NEW 4 RING STATOR	4
NEW LIP SEALS	8
NEW PARKING GUIDE BRACKET AND PARKING PAWL	10
NEW TRANSAXLE CONTROLLER AND LOCATIONS	12
NEW BELL HOUSING BOLT PATTERNS	15
NEW 4 DISC OVERDRIVE CLUTCH ASSEMBLY	20
NEW PRNODL AND NEUTRAL SAFETY SWITCHES	26
NEW GEAR RATIOS AND IDENTIFICATION	28
NEW (5TH DESIGN) TRANSAXLE CONTROLLER	32
NEW 1990 1/4 OVERDRIVE/REVERSE PISTON	33
NEW 1990 1/4 INPUT CLUTCH HUB	38
2/4 AND L/R CLUTCH PACKS (ASSEMBLY TIP)	42
PREMATURE FAILURE OF O.D. AND REVERSE CLUTCHES	45
FAULT CODES	46
FAULT CODE EXPLANATION	47
DIAGNOSTIC CONNECTOR LOCATION	72

AUTOMATIC TRANSMISSION SERVICE GROUP

Chrysler A604

Figure 25

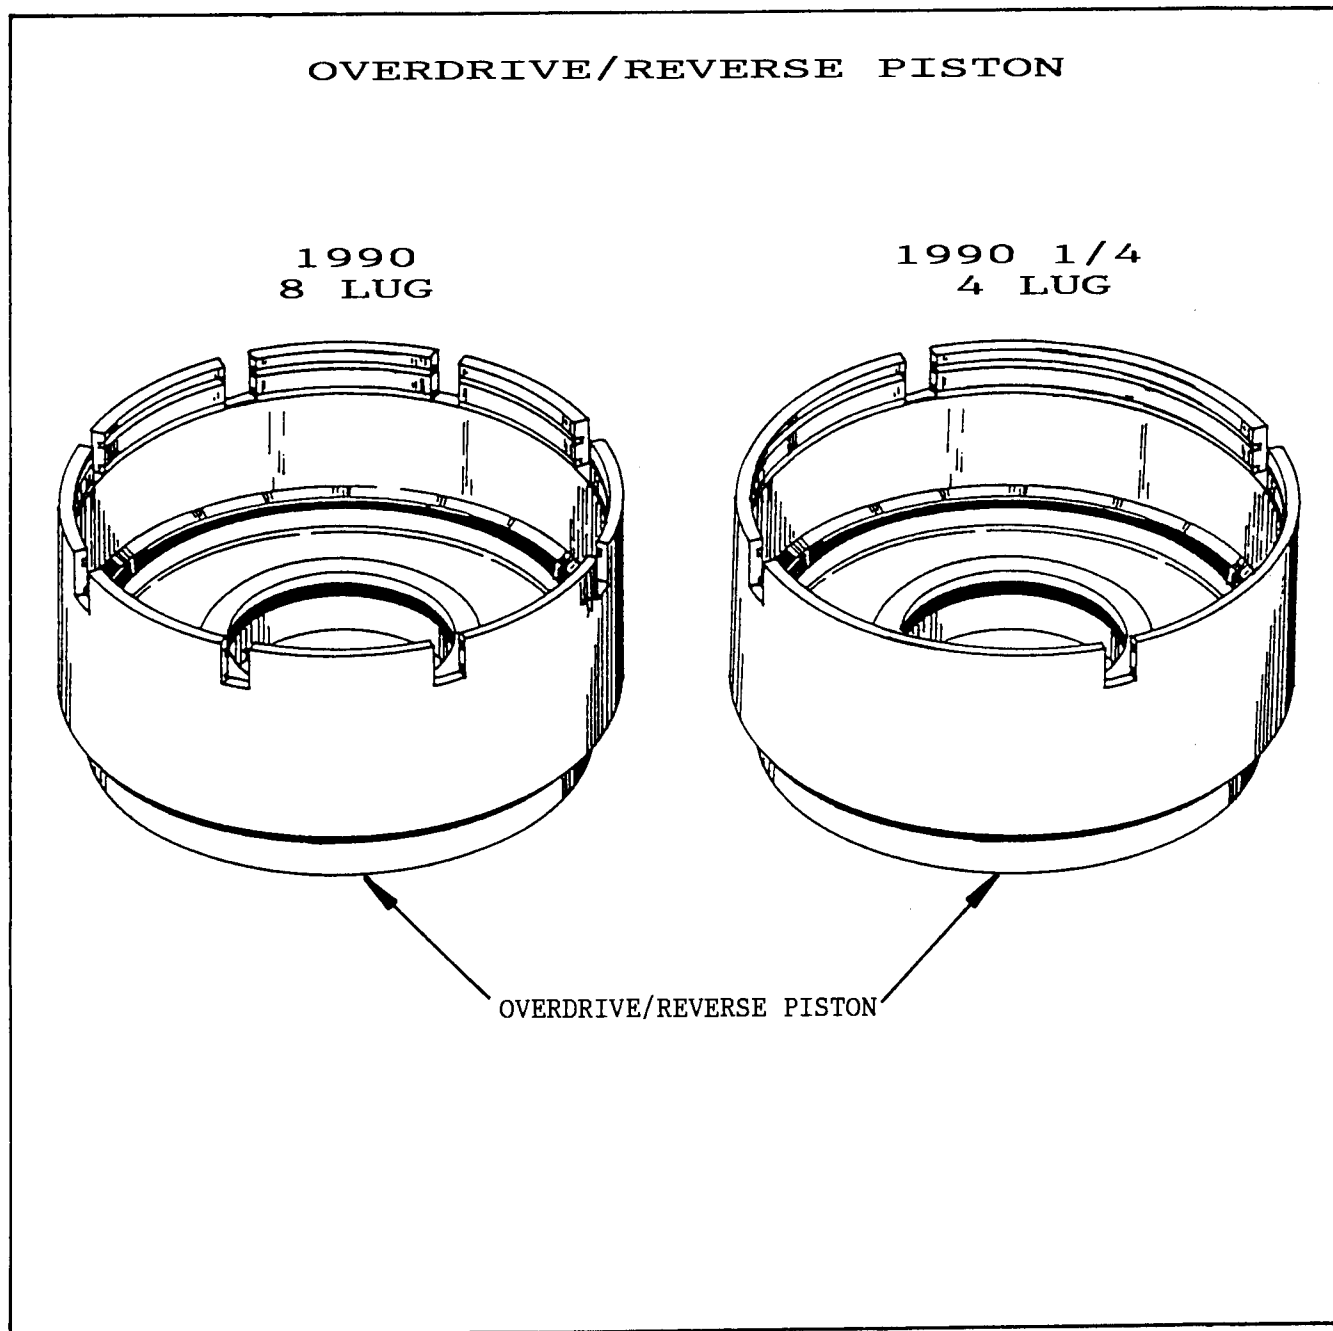
CHANGE: A new Overdrive/Reverse Piston has been introduced for 1990 1/4 model transaxles, and features four reaction plate slots instead of eight slots (See Figure 25).

- (1) OVERDRIVE/REVERSE PISTON - The new Overdrive/Reverse Piston has four slots, for the pressure plate lugs, instead of the previous eight slots and can be identified visually (See Figure 25).
The inside diameter of the new pistons bottom corner also has a larger radius to accomodate a new 1990 1/4 Input Clutch Retainer dimensional change (See Figure 26).
- (2) OVERDRIVE/REVERSE PRESSURE PLATE - The new Overdrive/Reverse Pressure Plate has only four lugs on the outside diameter, instead of the previous eight, and can be identified visually (See Figure 27).
- (3) INPUT CLUTCH RETAINER - The new Input Clutch Retainer has a new radius on the outside diameter, to reduce the chance of damage to the lip seal during assembly (See Figure 28). This retainer has no identification marks, and is tough to identify visually. The OEM part number did not change.

The new Overdrive/Reverse Piston, and four lug pressure plate will retro-fit back to all previous models, if it is used as an assembly. The piston and pressure plate must BOTH be used in these instances.

Figure 28

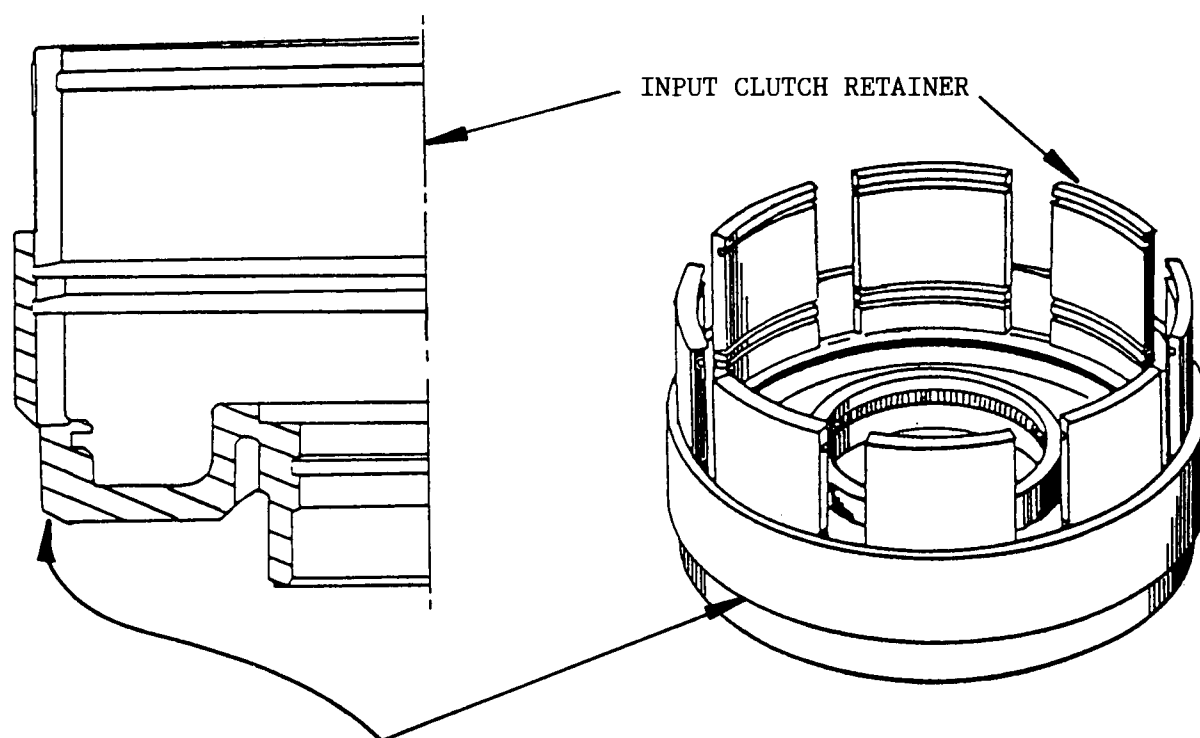
1990 1/4 INPUT CLUTCH RETAINER HAS A REVISED RADIUS, LOCATED HERE, ON THE OUTSIDE DIAMETER TO REDUCE THE CHANCE OF DAMAGE TO LIP SEAL.

The revised Input Clutch Retainer WILL NOT work with the previous style 8 lug overdrive/reverse piston. Since the part number did not change, to replace an input clutch retainer built in 1990, before the change to the 4 lug overdrive/reverse piston, you MUST also change to the 4 lug design piston and pressure plate.

Figure 29

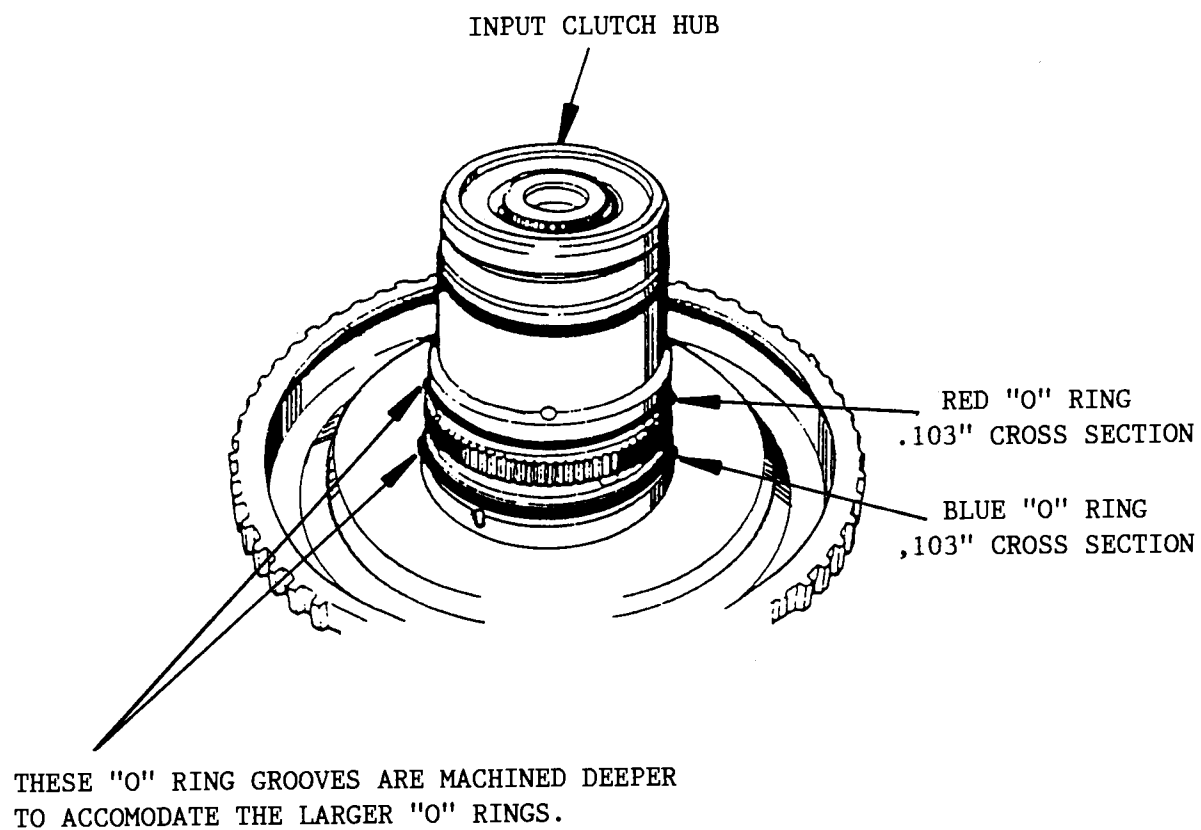
- (1) INPUT CLUTCH HUB - The "O" ring grooves on the Input Clutch Hub are cut deeper to accomodate the larger cross section color coded "O" rings (See Figure 29).

The new Input Clutch Hub with the deeper "O" ring grooves, and the BLUE and RED "O" rings will retro-fit back to all previous models, but you MUST also use the 1990 input clutch retainer as well.

Figure 30

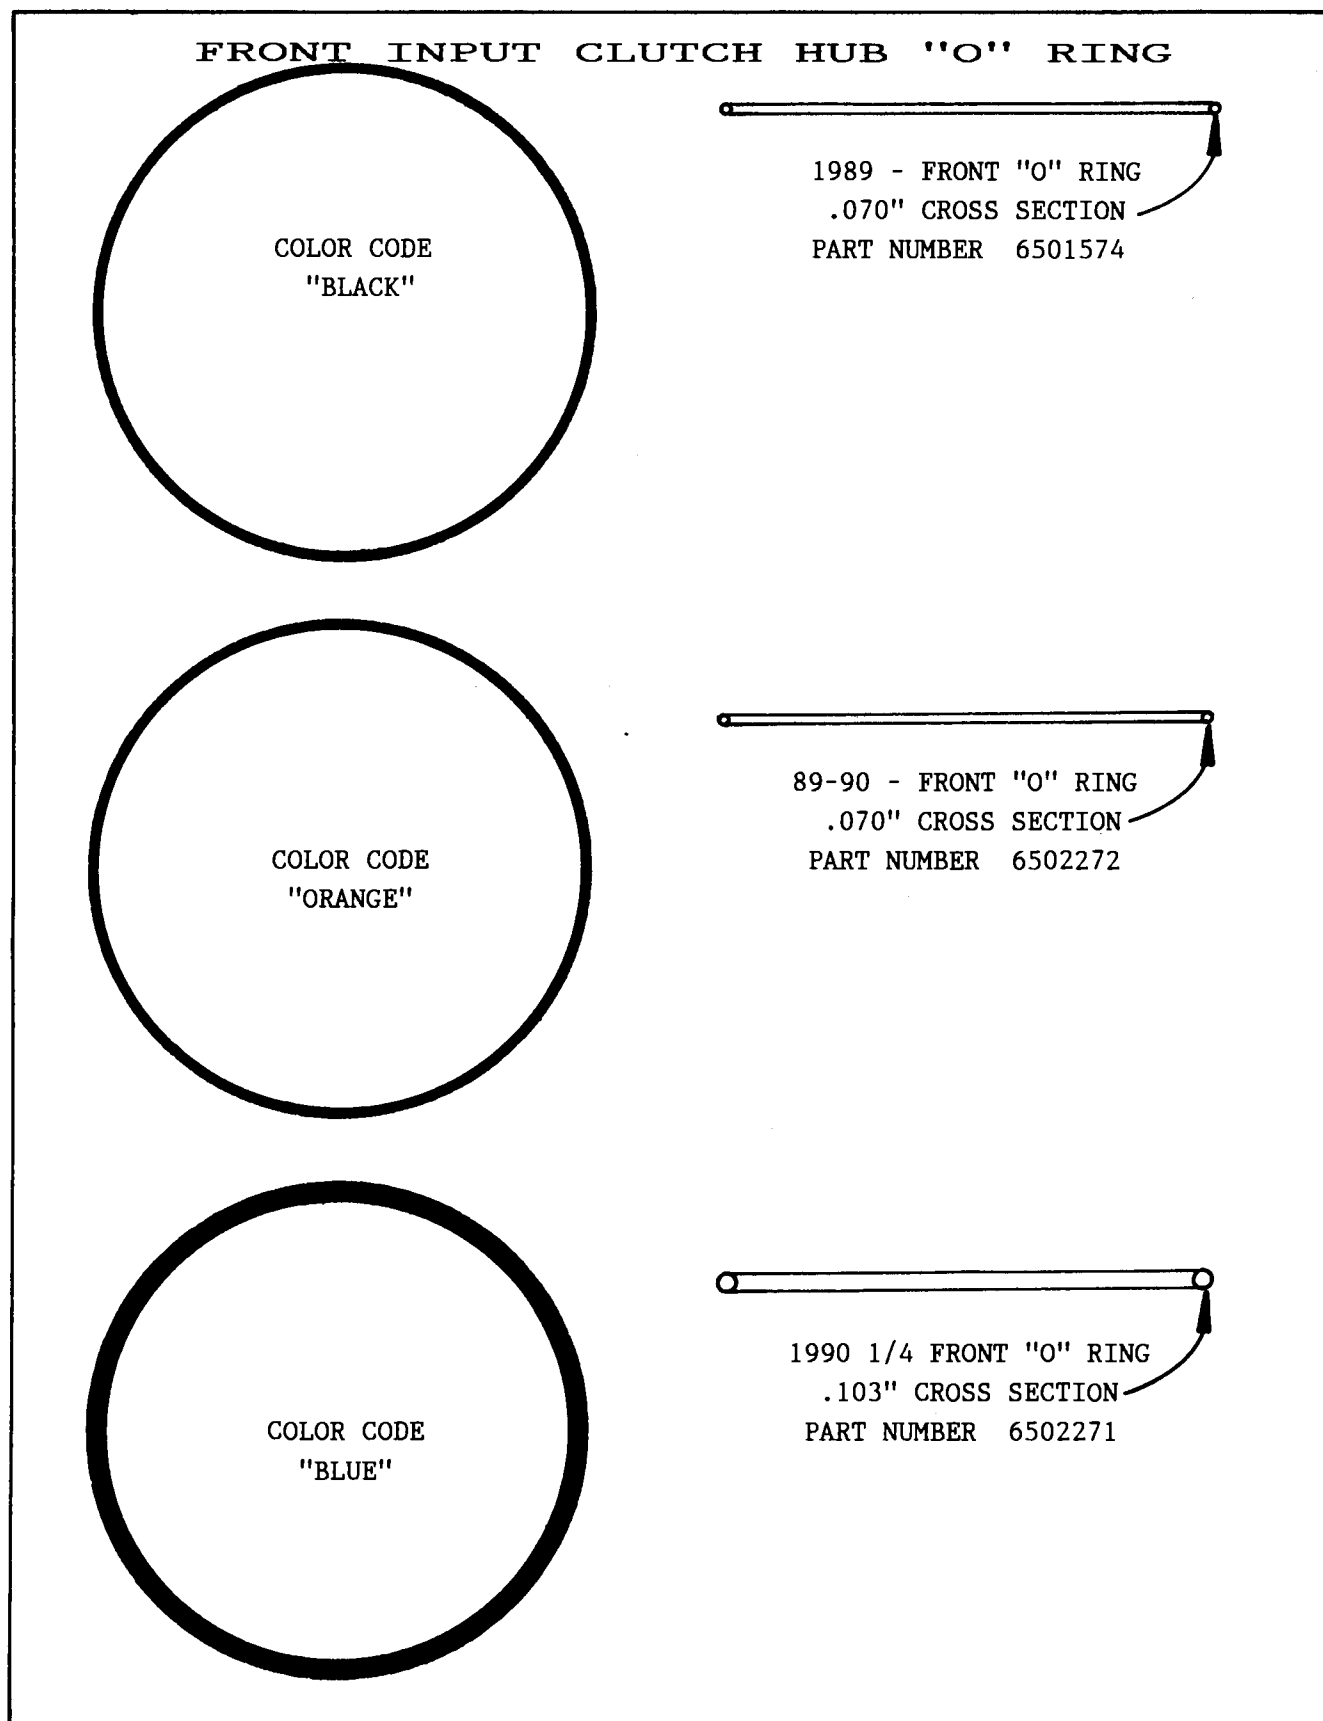
- (2) FRONT INPUT CLUTCH HUB "O" RING - This "O" ring now has a larger, .103" cross section and is color coded BLUE for identification purposes. Remember that this is the 3rd change on this "O" ring. The original "O" ring was BLACK with a .070" cross section, the 2nd design "O" ring was ORANGE with a .070" cross section, and the 3rd design "O" ring is BLUE with a .103" cross section (See Figure 30).

You CANNOT interchange the 1990 1/4 Input Clutch Hub "O" Rings (BLUE and RED) with the 89-90 "O" rings (ORANGE and GREEN), nor with the original (BLACK) "O" rings.

Figure 31

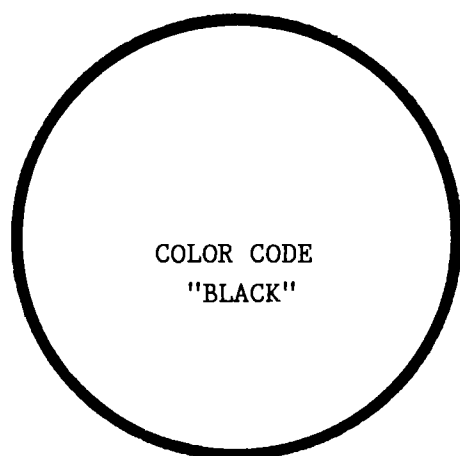
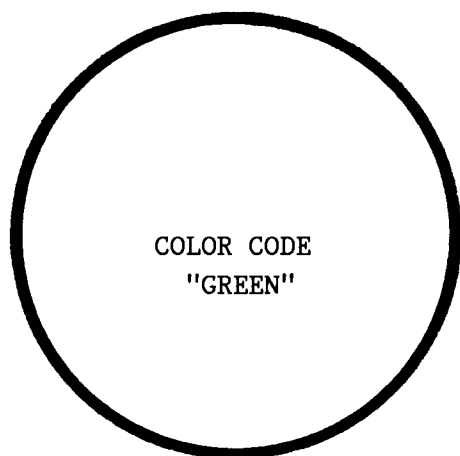
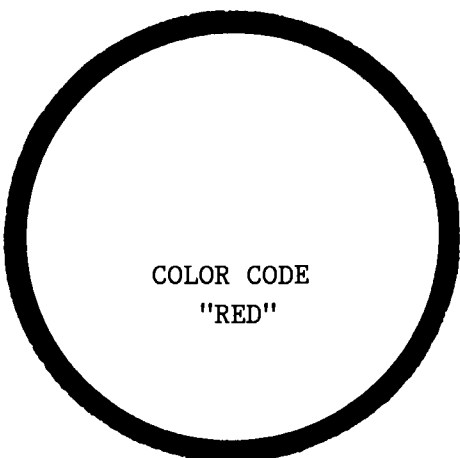
- (3) REAR INPUT CLUTCH HUB "O" RING - This "O" ring now has a larger, .103" cross section and is color coded RED for identification purposes. Remember that this is the 3rd change on this "O" ring. The original "O" ring was BLACK with a .070" cross section, the 2nd design "O" ring was GREEN with a .070" cross section, and the 3rd design "O" ring is RED with a .103" cross section (See Figure 31).

Figure 34

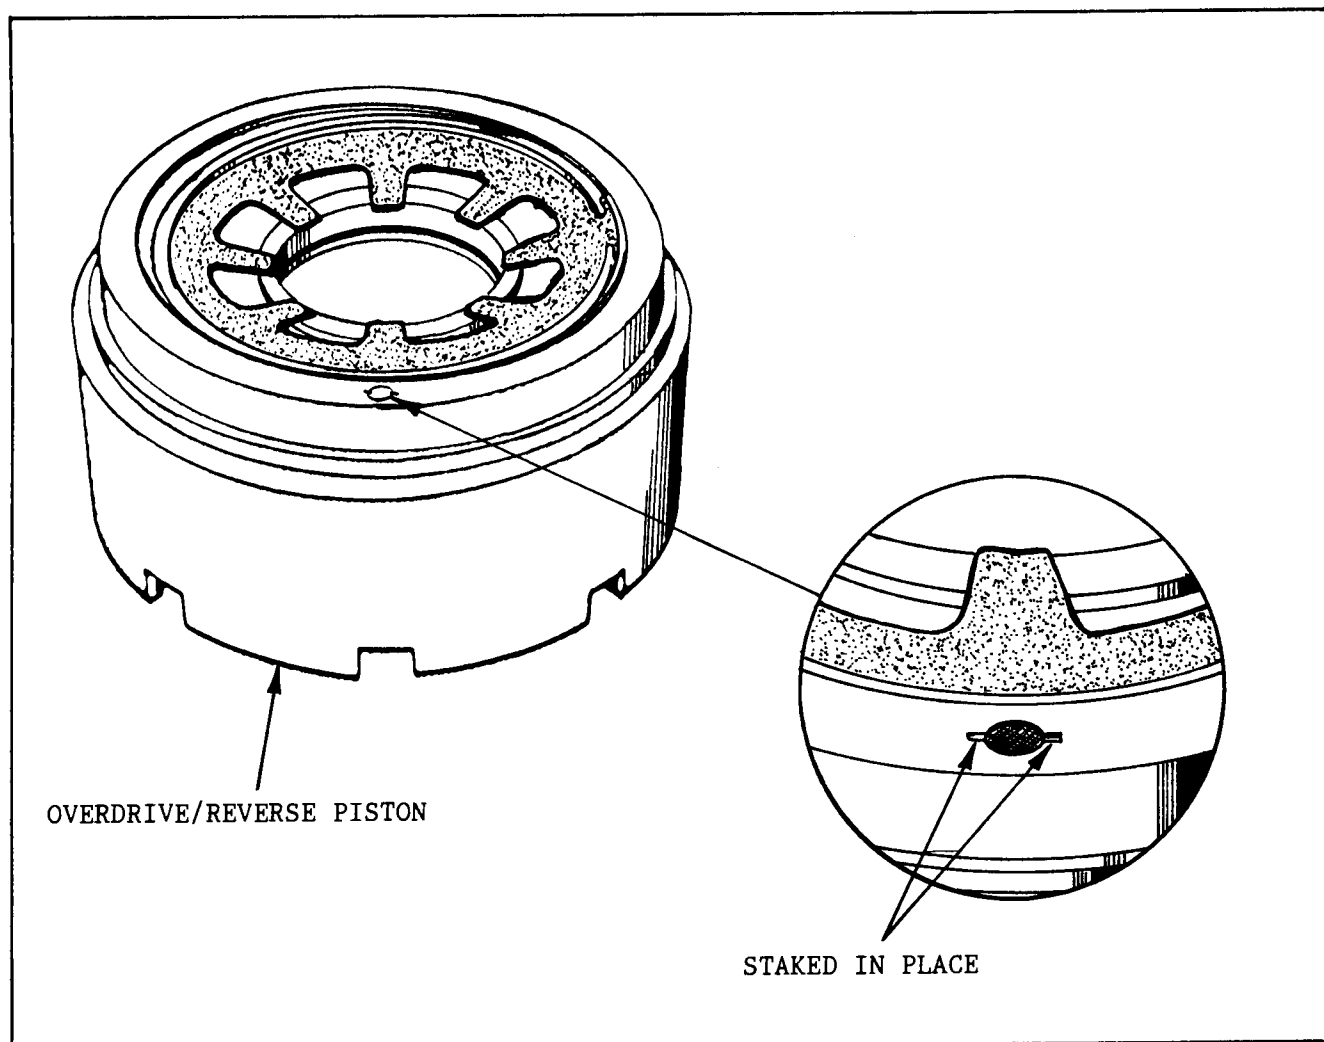
COMPLAINT: Premature failure of the overdrive and the reverse clutch plates, and all lip seals and "O" rings are good.

CAUSE: The cause may be an orifice and screen assembly blown out of the overdrive/reverse piston (See Figure 34).

CORRECTION: Replace the Orifice/Screen Assembly with a new one, available under OEM part number 4531903, and stake the new assembly in place (See Figure 34). They were not all staked in place at the factory.
